To: Parties to CPUC proceeding A.10-11-010 – Sale of SCE share of Four Corners
Generating Station

Re: Final Initial Study and Negative Declaration, and Response to Comments

Project: Four Corners Generating Station Project

Subject: Response to Comments Received on the Draft IS/ND

B - 7

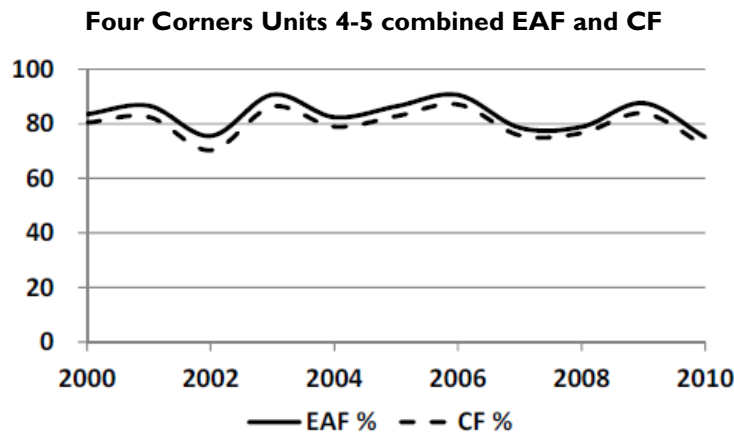
Under CEQA, the IS/ND must evaluate potential emissions for future operations from the project subject to the Act. The following sections present an analysis of a) the potential increase in greenhouse gas emissions due to improved reliability of Units 4-5 resulting from the above discussed capital improvements and b) a revised worst-case emission scenario.

Figure VI-1
Four Corners Units 4&5 Combined EAF and CF

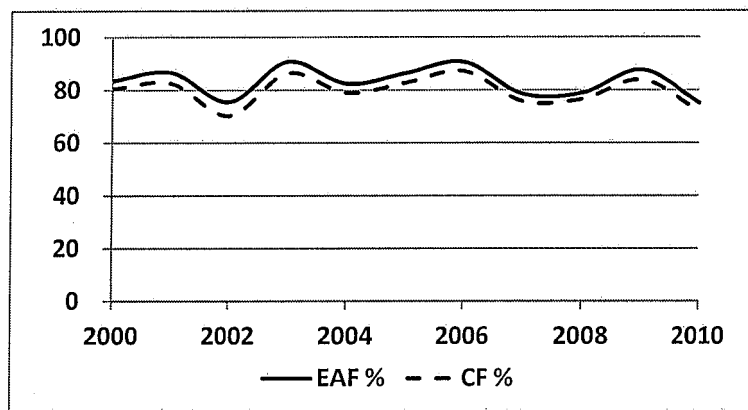
7 Sierra Club's claim is demonstrably false. As shown in Figure VI-1 below, Units 4 and 5 have
8 already operated at relatively high reliability (i.e., Equivalent Availability Factor) and Capacity Factor
9 for many years. As a practical matter, there simply is not much room for further improvement, and
10 certainly not by continuing to maintain the plant in like fashion to what has been done in the past.

8 Figure VI-1 also shows that Unit 4 and 5 EAF and CF (i.e., annual generation output) have been
9 relatively flat over the past 11 years. The dips and peaks in CF and EAF primarily reflect the timing of
10 major outages. These major outages include the routine major overhauls discussed above, as well as
11 unplanned turbine repair outages lasting several weeks experienced in 2007 on both units due to turbine
12 blade failures. These major outages explain why the EAFs recorded in 2002, 2004, 2007, 2008 and 2010
13 are all lower than all of the EAFs recorded in 2000, 2001, 2003, 2005, 2006 and 2009.

14 Figure VI-1 shows no discernable trend to support Sierra Club's allegation that 2007-2014 capital
15 expenditures at issue in this proceeding have caused, or will cause, reliability to increase, rather than to
16 be sustained at recent historic levels. In fact, the EAF recorded during 2007-2010, at approximately
17 80%, is actually lower than that recorded during 2000-2006 at approximately 85%. The EAF recorded to
18 date through May 2011 (the most recent month of available statistics) shows no evidence of appreciable
19 changes in EAF performance, with a 2011 year-to-date EAF of approximately 80.8%, which is slightly
20 below than the 2000-2010 average of approximately 83%. The 2011 data also does not show any
21 evidence of appreciable changes in CF performance, with a 2011 year-to-date CF of approximately
22 73.8%, which is below than the 2000-2010 average of approximately 82.1%.

*Figure VI-1
Four Corners Units 4&5 Combined EAF and CF*

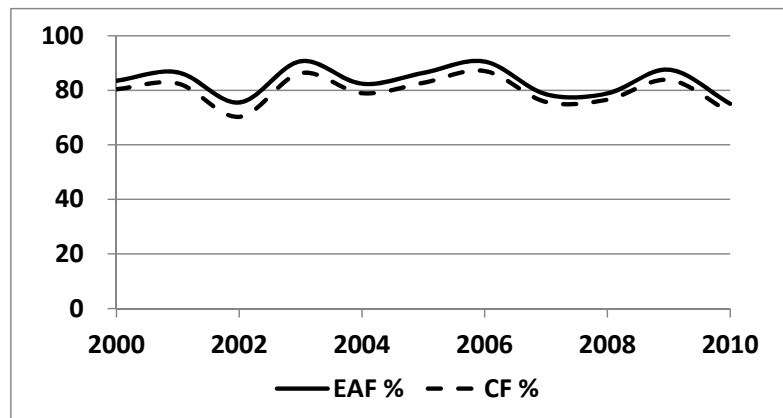
7 Sierra Club's claim is demonstrably false. As shown in Figure VI-1 below, Units 4 and 5 have
8 already operated at relatively high reliability (i.e., Equivalent Availability Factor) and Capacity Factor
9 for many years. As a practical matter, there simply is not much room for further improvement, and
10 certainly not by continuing to maintain the plant in like fashion to what has been done in the past.

8 Figure VI-1 also shows that Unit 4 and 5 EAF and CF (i.e., annual generation output) have been
9 relatively flat over the past 11 years. The dips and peaks in CF and EAF primarily reflect the timing of
10 major outages. These major outages include the routine major overhauls discussed above, as well as
11 unplanned turbine repair outages lasting several weeks experienced in 2007 on both units due to turbine
12 blade failures. These major outages explain why the EAFs recorded in 2002, 2004, 2007, 2008 and 2010
13 are all lower than all of the EAFs recorded in 2000, 2001, 2003, 2005, 2006 and 2009.

14 Figure VI-1 shows no discernable trend to support Sierra Club's allegation that 2007-2014 capital
15 expenditures at issue in this proceeding have caused, or will cause, reliability to increase, rather than to
16 be sustained at recent historic levels. In fact, the EAF recorded during 2007-2010, at approximately
17 80%, is actually lower than that recorded during 2000-2006 at approximately 85%. The EAF recorded to
18 date through May 2011 (the most recent month of available statistics) shows no evidence of appreciable
19 changes in EAF performance, with a 2011 year-to-date EAF of approximately 80.8%, which is slightly
20 below than the 2000-2010 average of approximately 83%. The 2011 data also does not show any
21 evidence of appreciable changes in CF performance, with a 2011 year-to-date CF of approximately
22 73.8%, which is below than the 2000-2010 average of approximately 82.1%.

Figure VIII-2
Four Corners Units 4&5 GWH and Greenhouse Gas (CO2) Emissions, 2000-2010

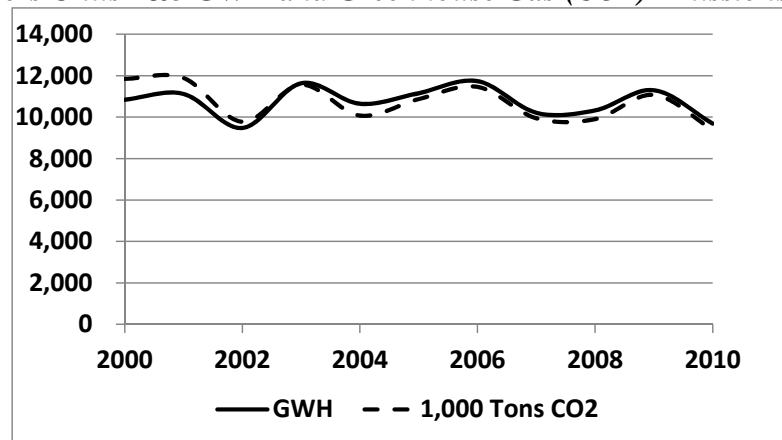
8 Figure VIII-2 below provides annual recorded GWH production (i.e., 1,000 MWH) and GHG
9 emissions from Units 4&5 (combined) for 2000 through 2010.³⁷

10 The above figure essentially matches the Units 4&5 Capacity Factor and EAF Figure VI-1
11 discussed above in Chapter VI. For the same reasons discussed there, the peaks and valleys in the above
12 figure primarily reflect the extended outages conducted in 2002, 2004, 2007, 2008 and 2010. As is the
13 case for CF and EAF, there is no discernable trend that GHG emissions or MWH production levels
14 during 2007-2010 are different than those recorded during 2000-2006. As also discussed in Chapter VI,
15 given that projects forecast for 2011-2014 are very similar to those completed during 2007-2010, there is
16 no reason to conclude that annual GHG levels will appreciably change as a result of these expenditures
17 as compared to 2000-2010 levels, or annual MWH generation levels (i.e., other than perhaps a small
